SUBJECT: Application for a Certificate of Compliance for the Mixed Oxide Fresh Fuel Package, Revision 1, DOCKET No. 71-9295

Reference: NRC Letter, "Request for Additional Information – Mixed Oxide Fresh Fuel Package – Docket No. 71-9295," dated December 8, 2004

REQUEST FOR ADDITIONAL INFORMATION

Schematic of Strongback Top Plate Deformation

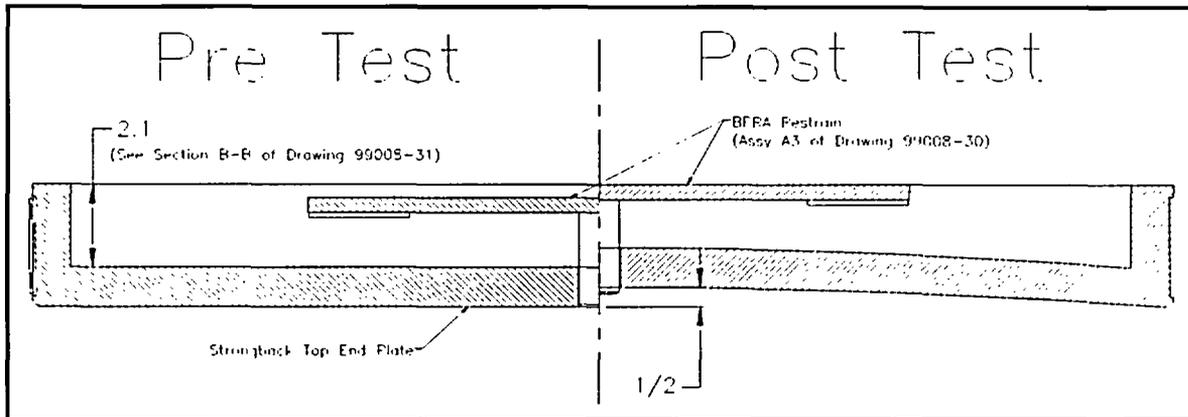
- 2-12 For the 30-ft C. G.-over-corner drop of Test Series 2, provide a discussion of structural damage, if any, to the closure lid/bolt assembly.

Item d, page 2.12.3-10, states, “The top plate of the strongback was permanently deformed outwards (towards the lid) by approximately 1/2 inch.” Section A-A of Drawing 99008-10 appear to show a nominal gap of less than 1/2 inch between the strongback top and the closure lid, which is less than the reported 1/2-inch outward deformation of the strongback top. This suggests that the closure lid/bolt assembly could have been subject to a puncture shear by the strongback and, thereby, damaged during the test.

Response: Additional discussion, including supporting figures and pictures, has been provided in Section 2.12.3.8.2.4 of the SAR. The top plate deformations described are the maximum, which occurs at the center of the strongback top plate. The design of the

top plate is such that there is a 2.1 inch thick 'rim' at the outer diameter, which provides the central portion room to deform. See the schematic below that shows the type of deformation, and where the deformation measurement was taken.
